# Technical Bulletin

Model  
911C2/C4

**Subject:** Valve Seat Depth Checking

Number  
9101

Figure 1

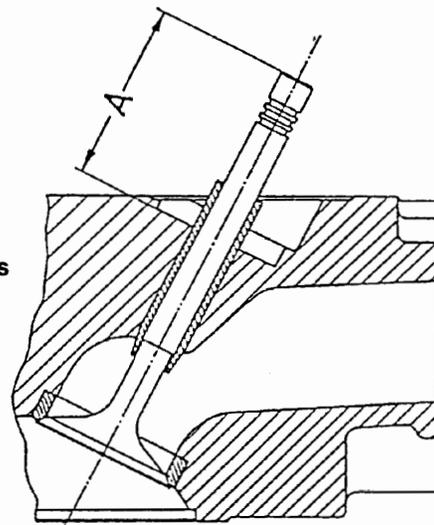
**Concern:** Checking valve seat depth

**Repair Information:** Distance A (Figure 1), valve stem end to cylinder head contact surface for the valve spring retainer, should not exceed  $45.5+0.3\text{mm}$  after machining valve seats.

A =  $45.5+0.3\text{mm}$   
Intake and  
exhaust valves

Measurement must be taken with valve spring, spring retainer, and shims removed. If distance exceeds the specified value with a used valve, measure again using a new valve. If distance still exceeds the specified value, replace the cylinder head.
